The Detroit Edison Company One Energy Plaza, Detroit, MI 48226-1279

February 15, 2010 NRC3-10-0005

Response to RAI letter related to Fermi 3 ER

RAI Question TE2.4.1-12 RAI Question TE2.4.1-13 RAI Question TE4.3.1-8 RAI Question TE4.3.1-9

Eastern Fox Snake Sightings Map (following 1 page)

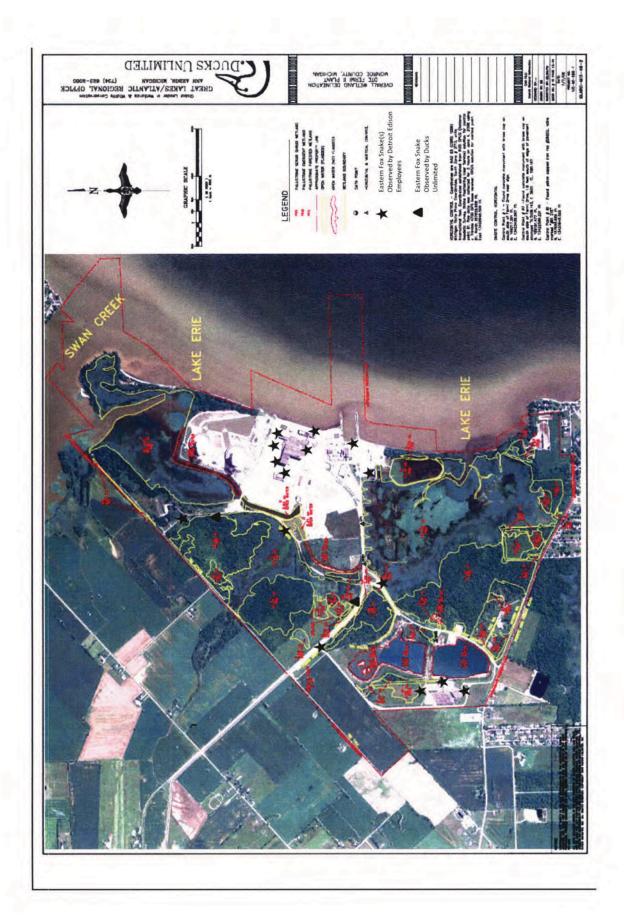
Provide up-to-date and complete data on the locations and dates of sightings of the eastern fox snake (Pantherophis gloydi) on the proposed Fermi 3 site, including any sightings by Detroit Edison staff or others in the last 10 years.

Information about the numbers and locations of sightings of the eastern fox snake in recent years would facilitate evaluation of the nature of this snake's population on the project site. In a phone conversation with Ecology and Environment, the Michigan Department of Natural Resources (MDNR) indicated that its records of a viable population of eastern fox snakes on the Fermi property come at least in part from reports by Detroit Edison personnel.

Detroit Edison should investigate its own records as well as coordinate with MDNR to determine the extent of recent and historical sightings data and to provide a basis for determining potential impacts to the eastern fox snake.

A map indicating where known observations of eastern fox snakes have occurred is provided as Enclosure 1 to this response. The sightings which are indicated as having been made by Detroit Edison employees (represented by stars on the map) were made from 1990 to 2007. Two sighting made by Ducks Unlimited (represented by triangles on the map) were made during a site wetland survey conducted in 2008.

At the locations where fox snakes were sighted by Detroit Edison employees, from 1-6 snakes have been observed per occasion. In addition, multiple sightings were made at each location over the course of the 1990-2007 period of time.
